Appendix R: Response to Public Hearing Comments

Appendix R provides a summary of the comments received during the public hearing comment period which extended from August 20 through September 19, 2018. Appendix Q contains copies of the comments. Comments are followed by a response and have been grouped by category. The commenter is identified in parentheses.

Figure 1 Comparing edge-of-field SnapPlus to delivered SWAT TP losses for subbasins of the Wisconsin River basin

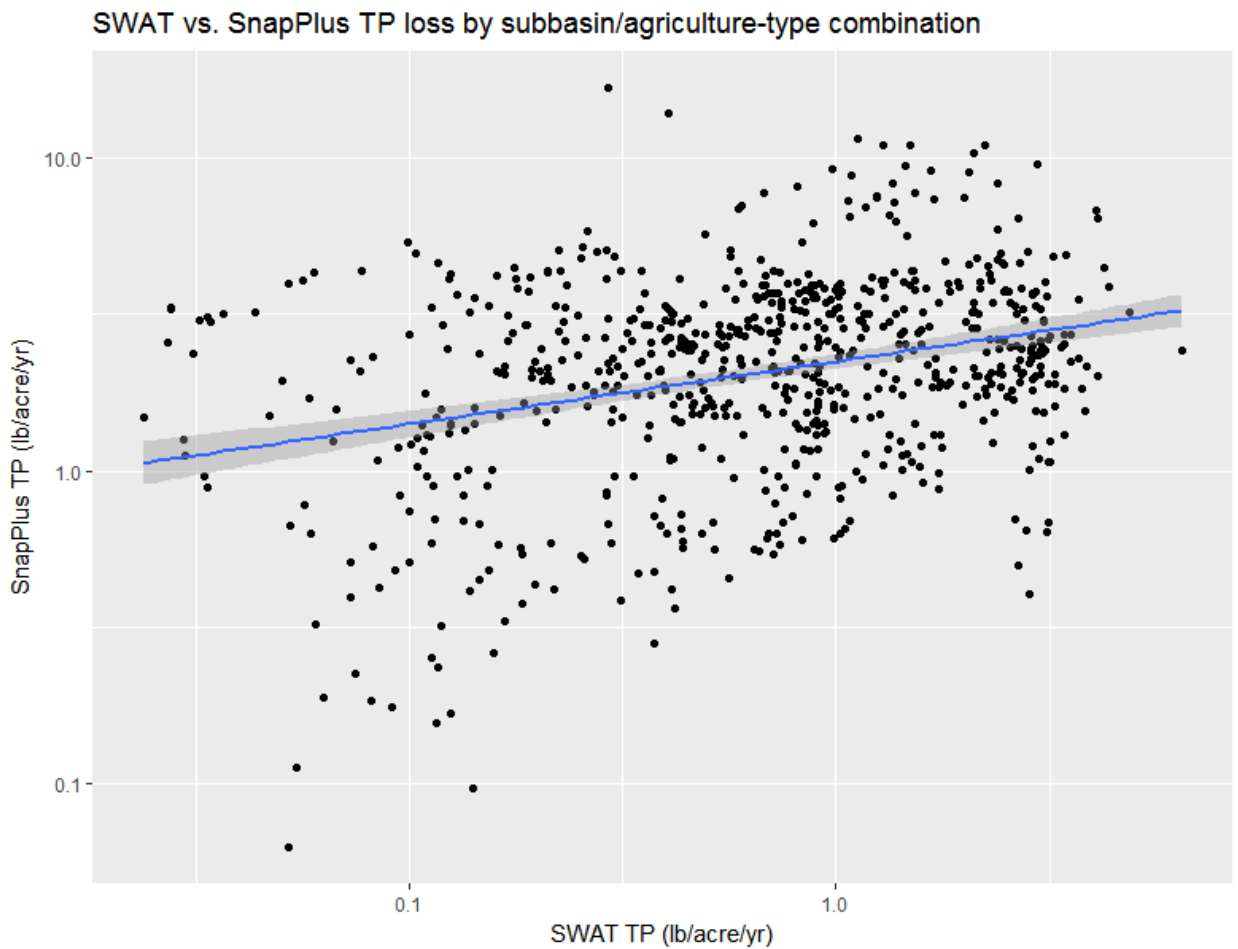
27. Appendix N is a valuable addition to the document and a step toward NPS implementation. It is evident that the phosphorus yield estimates in Appendix N do not agree with the baseline yield numbers from SWAT. However, they are important additions to the science of NPS management. They would be even more valuable if the sub-basin yield values from SWAT were listed in table 1.2 in Appendix N along with the PI values using the trade report method. Future implementation efforts will need to understand the difference between these yield estimation techniques. Also, future efforts to bring the SWAT and Snap plus models closer to the same yield estimates would benefit from listing both model outputs for each sub-basin in this evaluation. Include SWAT sub-basin phosphorus yield estimates alongside trade report PI yield estimated in table 1.2 of Appendix N. Also, the TMDL should recommend that the Snap Plus model be modified to automatically provide farm-wide weighted mean values for trade report phosphorus index and soil loss. This recommendation is an important part of reasonable assurance of nonpoint implementation. *(Wisconsin's Green Fire)*

Response: We appreciate your comment and look forward to using Appendix N to improve communication of TMDLs with the agricultural community. It's correct that there are differences between SWAT estimates and SnapPlus estimates, but they are correlated (unfortunately, the

Appendix N that was published as part of the public hearing process contained a programming error in the analysis, which has been corrected).

In response to this comment, we looked at the relationship between SWAT delivered HRU loads (the fraction of agricultural loads delivered to each SWAT reach) and SnapPlus edge-of-field loads. The magnitude of SnapPlus edge-of-field estimates is about 170% higher than SWAT HRU loads, and about 200% higher than SWAT delivered loads (about a 66% loss of phosphorus from the edge-of-field to the pour point of each reach, on average). The relationship between the two estimates, when averaged within subbasins, is present, yet there is still a significant amount of difference between the two:

Figure: Contribution of Different Sources at Various Points Along the Wisconsin River Mainstem:

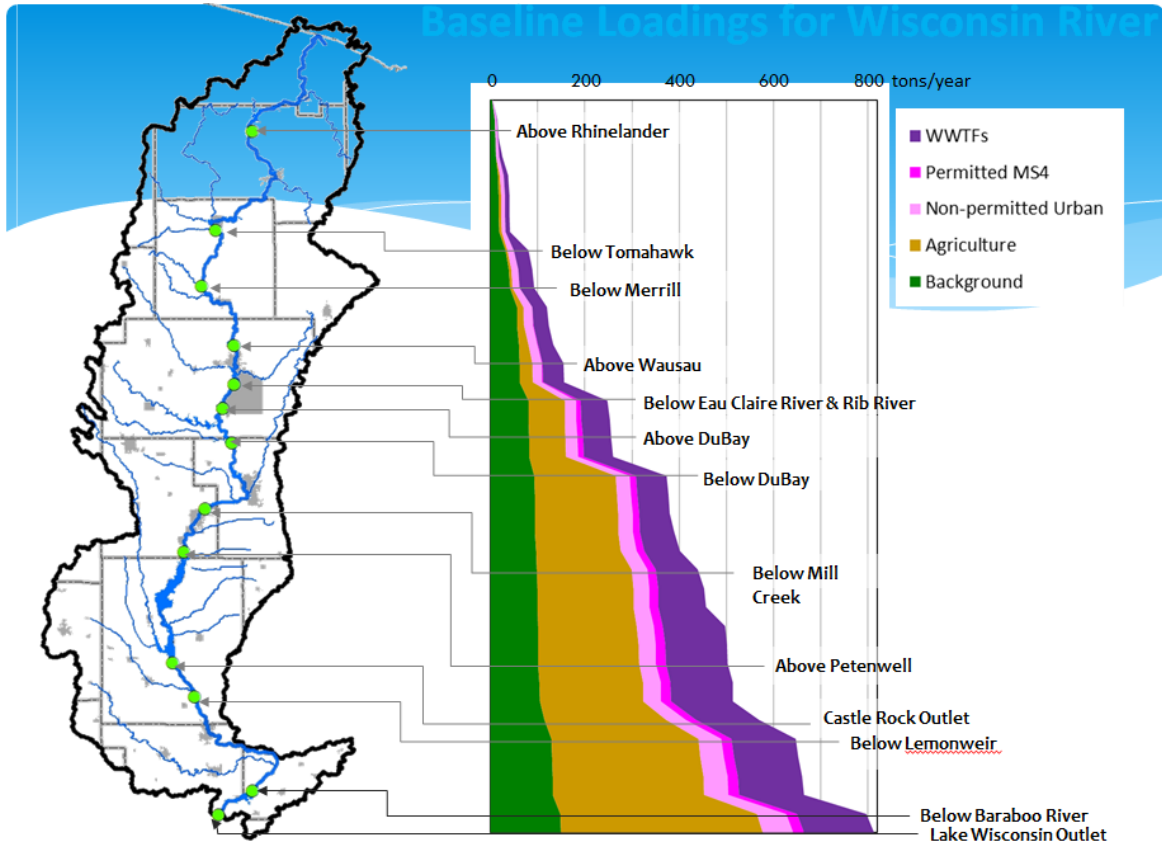
29. Wisconsin was a leader in establishing technology-based effluent limits on phosphorus back in 1992 at 1.0 mg/L. As a result, Wisconsin municipal treatment plants have already removed approximately 90% of the phosphorus in their discharges, and many have removed upwards of 97%. It is thus not surprising that most of the phosphorus impairments in Wisconsin's waters do not come from municipal treatment plants, but from nonpoint sources. The TMDL seeks to impose extremely restrictive limits on point source dischargers, despite the fact that baseline phosphorus loadings in the Wisconsin River TMDL area are dominated by nonpoint sources. Because point sources have already removed a substantial amount of phosphorus from their discharges, reducing phosphorus discharges from point sources to the level proposed in the TMDL will not result in significant water quality improvement. (*Stafford Rosenbaum on behalf of Municipal Environmental Group-Wastewater Division*)

Response: Response: It is true that many wastewater discharges have been subject to technology-based limits (TBELs) of 1.0 mg/l (or alternate TBELs > 1.0) since the initial promulgation of ch. NR 217, Wis. Adm. Code, in 1992. Those discharging less than 60 pounds per month (industry) or less than 150 pounds per month (municipal) were not subject to TBEL requirements and many are still discharging well above the 1.0 mg/l level. As shown in the figure below, wastewater treatment facilities are still a significant source of phosphorus in the Wisconsin River Basin with the exact percent varying based on rainfall. For example, in 2012 wastewater treatment facilities became the largest source of phosphorus in the Wisconsin River Basin.

Revisions to NR 217 in 2010 established water quality based effluent limits (WQBELs) for wastewater dischargers based on new water quality standards for phosphorus. WQBELs calculated according to s. NR 217.13, Wis. Adm. Code, can be stringent when local or downstream waters are impaired and water quality criteria are low. In many cases, the WQBELs derived from draft TMDL WLAs are less stringent than WQBELs derived from s. NR 217.13, because the TMDL takes contributions from nonpoint and other point sources into account.

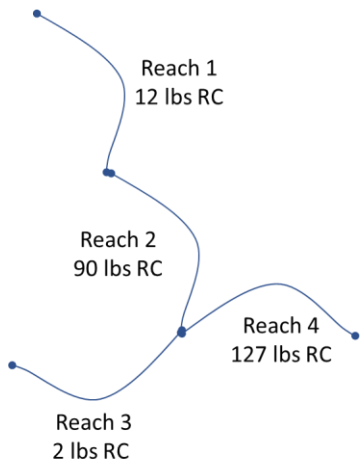
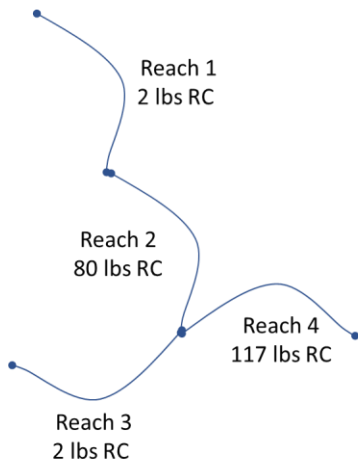
41. While we appreciate the explanation provided by the Department staff to the River Alliance comments concerning the reserve capacity in the prior draft TMDL, the process for determining where this reserve is allocated is still unclear. Clarity on the priorities and decision-making process would strengthen this section and ensure that permit holders could better understand how new or increased discharges will be addressed. *(Stewards of the Dells of the WI River)*

Response: The flexibility in apportioning reserve capacity is best illustrated by example. In this hypothetical example the watershed has four reaches and each reach contributes varying amounts of reserve capacity.

Because reserve capacity is additive as you move downstream, the total reserve capacity available at Reach 4 is 351 lbs./yr. Facility A, a new discharge, wishes to locate in Reach 4, and it has been determined that they are eligible for 120 lbs./yr. of reserve capacity. Since there are four reaches, 30 lbs./yr. of reserve capacity could be taken from each one, resulting in a new distribution of reserve capacity:

Sometime later, Facility B wishes to locate in Reach 3, and it has been determined that they are eligible for 30 lbs./yr. of reserve capacity. Since Reach 3 is a headwater reach, any reserve capacity used must come from that reach. To account for this new discharge, the 30 lbs./yr. of reserve capacity from Reach 3 used to accommodate the discharge from Facility A can be reapportioned among Reaches 1, 2 and 4 to allow for Facility B to use 30 lbs./yr. of reserve capacity in Reach 3:
